STATE OF UTAH
NATURAL RESOURCES
Oil, Gas & Mining

June 25, 1987

RE: Review of Proposed Mine Development and Potential Subsidence Impacts, New Lands Property, Plateau Mining Company, Folder No. 2, ACT/007/006, Carbon County, Utah

Figure 30 - Generalized Strata Behavior Above a Panel Under Total Extraction

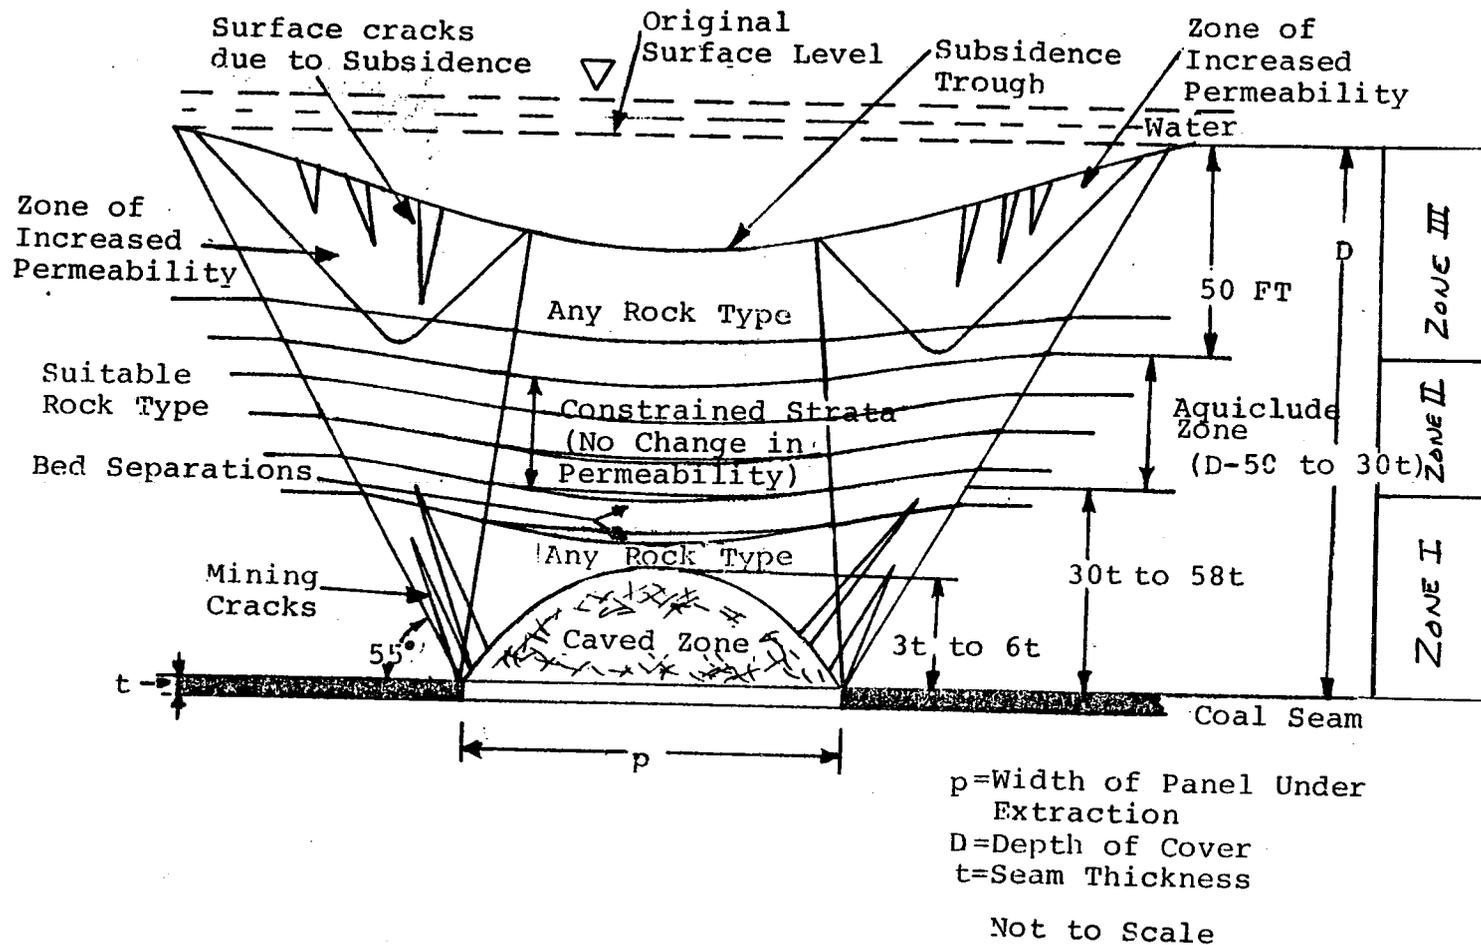
The applicant's methodology for assessing potential subsidence impacts consists of subdividing the overburden above mined areas into three zones that are characterized by different types of rock failure. The vertical extent to which these zones propagate is presumed to be a function of overburden lithology, mining methods, and extraction thickness. The three zones are characterized, in ascending order, as follows.

Zone 1: Immediate roof, highly stressed and free to collapse.

Zone 2: Rocks will deform and fracture, but maintain their lateral continuity because of lateral confinement. Fracturing is associated with lateral expansion resisted by the sidewalls of the excavations.

Zone 3: Adjacent to the surface. Open cracks may develop at the surface due to the lack of lateral confinement. Open cracks are believed to cease at a depth of 45 feet due to lateral confinement and transition to Zone 2.

The applicant's analysis of potential mining-induced subsidence impacts may be somewhat optimistic upon close inspection of the premises used to develop the zonation methodology for restricting longwall panel locations.

In summary, the implied inference that undermined rocks will fail in a similar manner and Zone 1 will propagate to a height comparable to that measured in the Donets Coal Field is, herein, considered speculative.

Site-specific lithologic data combined with recommendations by Engineers International (1979) suggests the applicant has underestimated the Zone 2 thickness.

ALTERNATIVE 2.

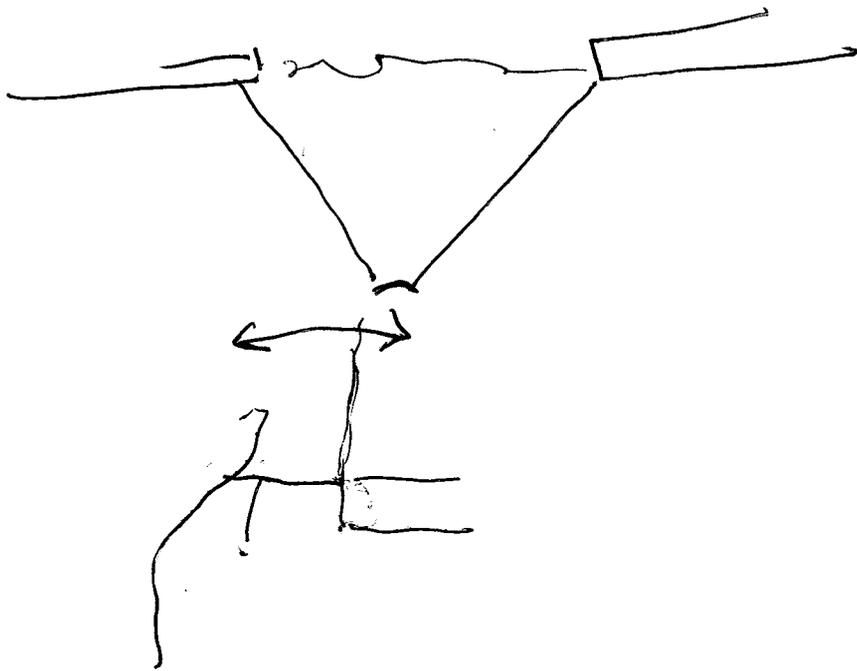
Alternative 2 (see attached figure)

Restrict applicant to longwall mining in panel three of the Wattis seam only where overburden exceeds 500 feet. Allow room and pillar mining with pillar retention in panel three of the Wattis seam where overburden thickness is between 400 and 500 feet. Exclude Third seam mining from permit approval until impacts from Wattis seam mining can be assessed.

Based on discussions both internal and with Plateau, I recommend that the alternative listed as "Alternative 2", be followed for the sake of making compliance findings. This course of action is not designed to preclude the applicant from proposing mining in to Third seam, but before such mining can proceed, the ramifications of Wallis seam removal should be reviewed by DOGM. This review should be concluded 1 year prior to proposed 3rd seam mining. L.B. Braxton 7-16-87

ALTERNATIVE 3.

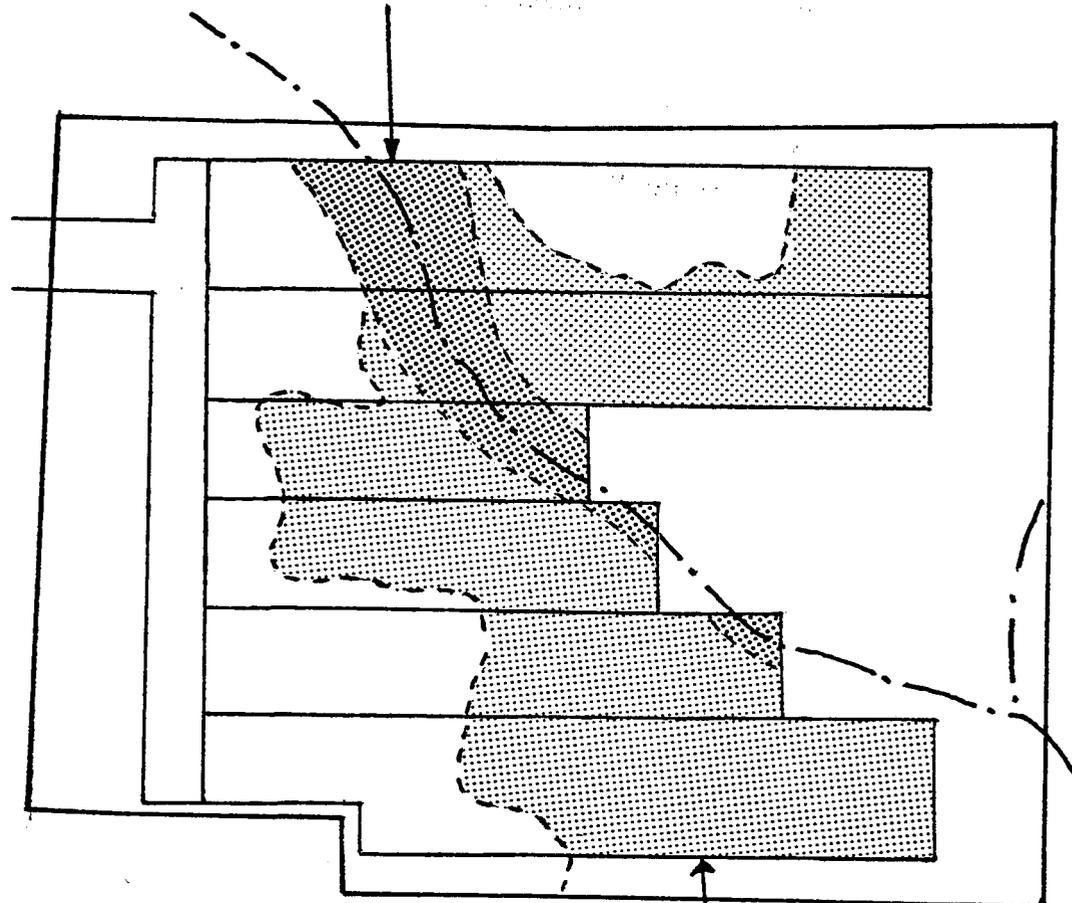
Alternative 3 (see attached figure)

Restrict applicant to Wattis seam mining with retention of subsidence barriers (1) sized according to the 22.5 degree angle-of-draw, beneath NFRF Miller Creek and (2) past outcropping Castlegate Sandstone. Exclude Third seam mining from permit approval until impacts from Wattis seam mining can be assessed.
